Car Stereo  
Service Bulletin

**Model:** XE-8

**No.** 128

**Subject:** System With XE-8 Does Not Operate **Date:** May 8, 1989

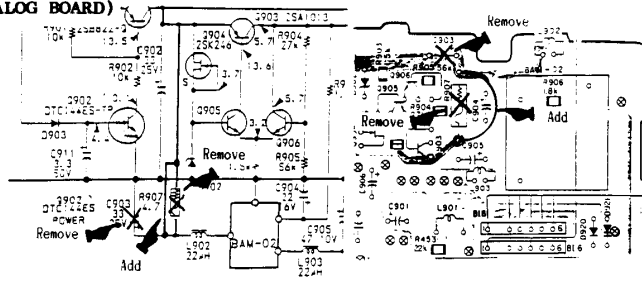
The entire system in the car does not operate. The symptoms on the XE-8 itself are:

1. Remains illuminated continuously.
2. Spectrum Analyzer display is fully lit. This is caused by the battery mirror circuit not turning on.

**Solution:** Change the following parts:

Ref. No.	Description	
	Former	New
R504	5.6k Ohm	47k Ohm
R515	5.6k Ohm	
R673	2.4k Ohm	3k Ohm
R705	10k Ohm	150k Ohm
R907	4.7 Ohm	Remove and Short-Circuit With Wire
C903	33uF/25V	Remove
D672 D673	----	Add 1SS199
----	----	Cut a Pattern
